RE: St. Lucie Units 1 and 2
Docket Nos. 50-335 and 50-389
Response to NRC Request for Additional Information
Generic Letter 96-06 Waterhammer Issues

The Florida Power & Light Company (FPL) supplemental response to Generic Letter 96-06, for St. Lucie Units 1 and 2 is attached. This supplement provides a response to the NRC second request for additional information (RAI) dated August 1, 2003.

Attachment
St. Lucie Units 1 and 2 Response
NRC Request for Additional Information Dated August 1, 2003
Regarding GL 96-06 Waterhammer Issues

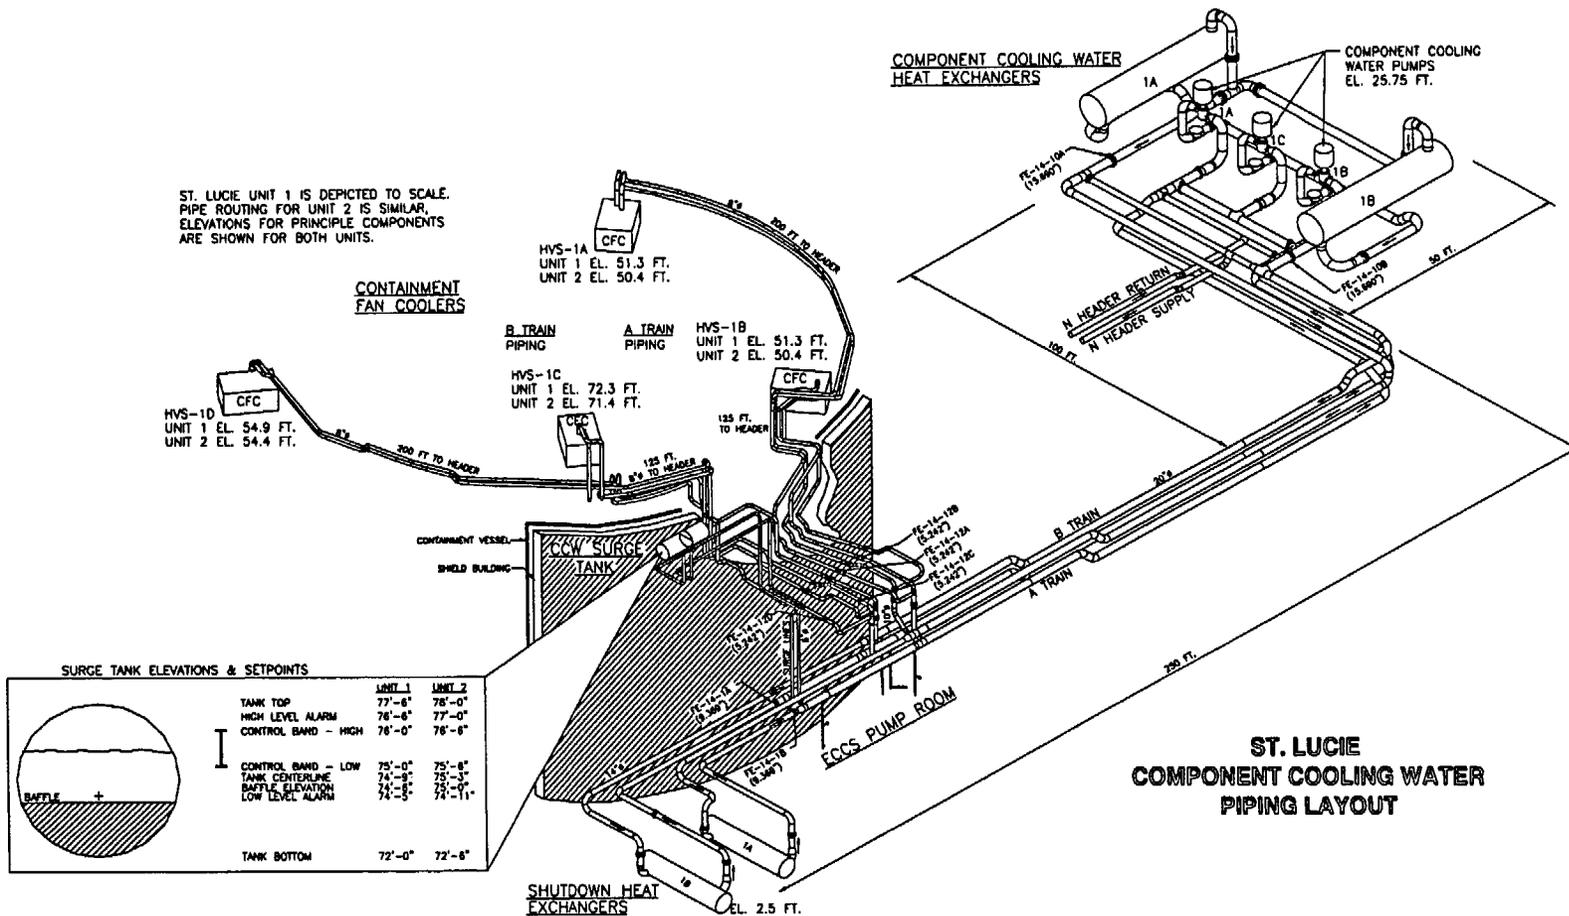
Information concerning the number of pumps starting in the benchmark test and LOOP-only scenario, and maximum flow rates expected within the system after pump restart is provided as follows:

Parameter	Test Condition	LOOP Only Condition
Number of Pumps Starting	1 (half system w/SDC Hx)	2 (N-header not isolated)
Maximum flow rates	~7640 gpm per pump	~5700 gpm per pump
Flow rate at the CFC	~1350 gpm	~1400 gpm

Benchmark test measurements were taken at pipe penetrations adjacent to the outside containment shield building wall. Relative locations to system components are shown on the following figure.

FIG 1. HYTRAN MODEL OF LOOP B PIPING - SCHEMATIC

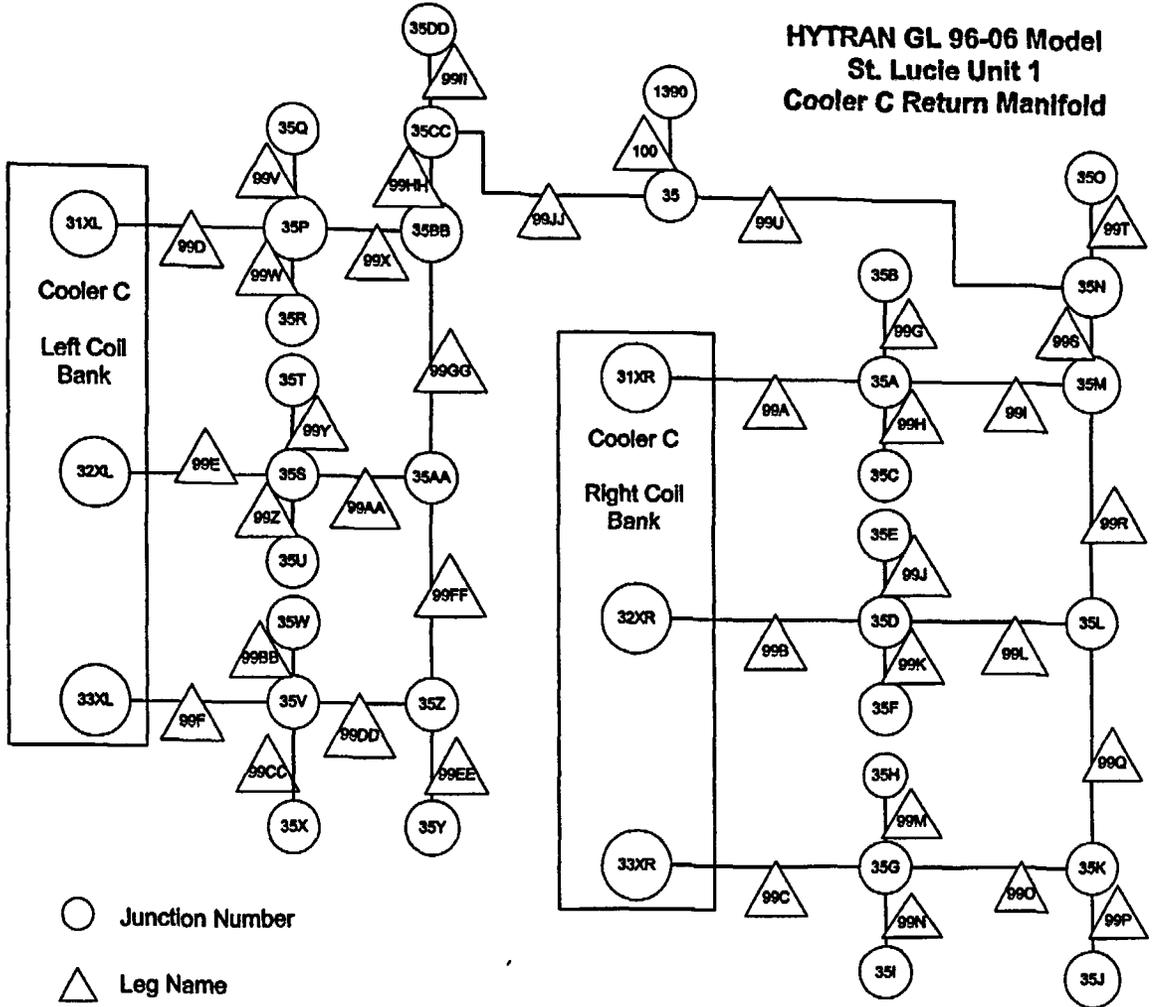
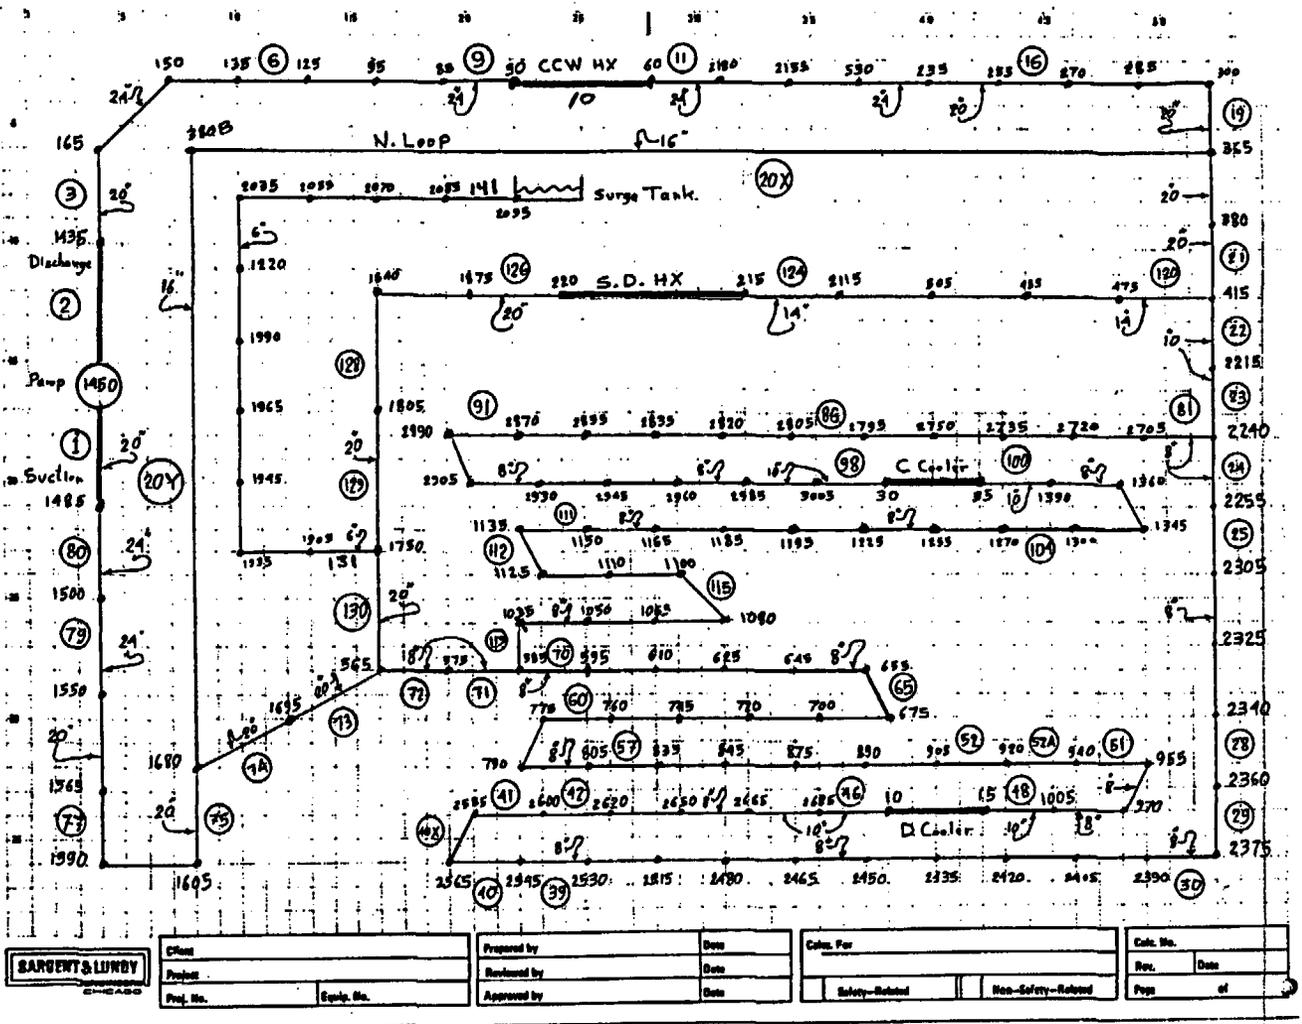
NRC Question 3- The submittal states that the HYTRAN code was used to predict peak pressure produced in the waterhammer analysis. The NRC staff has not previously reviewed the HYTRAN code for waterhammer analysis within CCW piping. Provide either the HYTRAN code for staff review, or provide an analysis of the most severe waterhammer postulated within the CCW piping using the Electric Power Research Institute (EPRI) methodology that the staff has approved. If you choose to apply the EPRI methodology rather than submitting the HYTRAN code for staff review, provide the following information:

- a. *The maximum CCW velocity following pump restart.*
- b. *Mass of gas in the void. Provide justification that the minimum noncondensable mass for use of the EPRI methodology will be present.*
- c. *Amount of cushioning credited. Reference the nomograph used to determine cushioning.*
- d. *Assumptions regarding pressure pulse shape.*
- e. *Assumptions regarding pressure pulse duration.*
- f. *Transmission coefficients used to track the pressure wave through the CCW piping.*
- g. *Pressure pulse clipping.*

The following Load Comparison Table compares RBM and HYTRAN/MOC maximum leg forces. The accompanying Node Point/Leg Sketches indicate the locations of the legs.

Maximum Forces at 45 Pipe Legs for Various Void Sizes

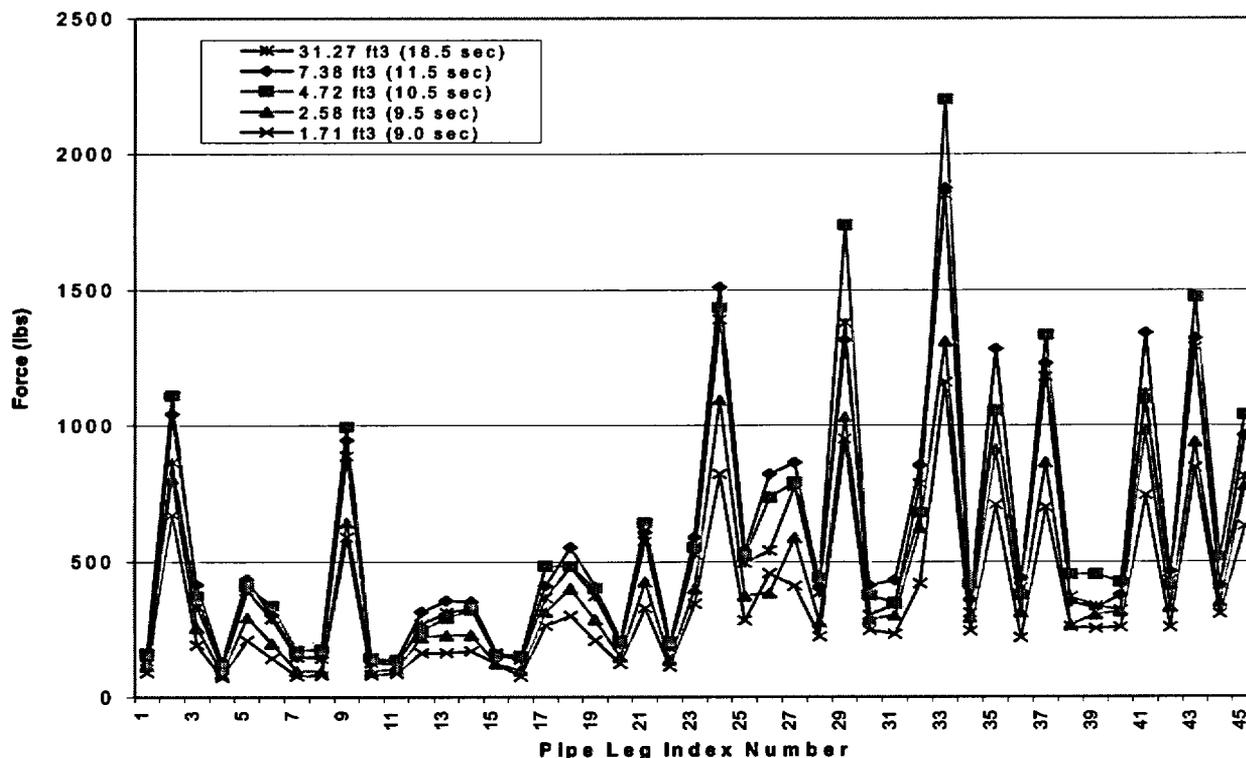
NRC Question 8 - Page 11 of the submittal states that the loads and stresses are "not sensitive to void size." Explain.

A parametric review was performed with respect to the affect of void size on maximum pipe segment loads for the 45 legs in the CFC return lines within the Unit 1 B CCW train for five arbitrary void volumes. The effect of void size on pipe segment loads is shown below. The results indicated that the loads were very small at low void size (1.71 ft³), increased as void size increased (2.58 ft³ to 4.72 ft³), decreased slightly at 7.38 ft³ and dropped off again at a void size of 31.37 ft³. The variance in the maximum loads between the analyzed case (7.38 ft³) and other void sizes reviewed ranged from 10% to 25%.
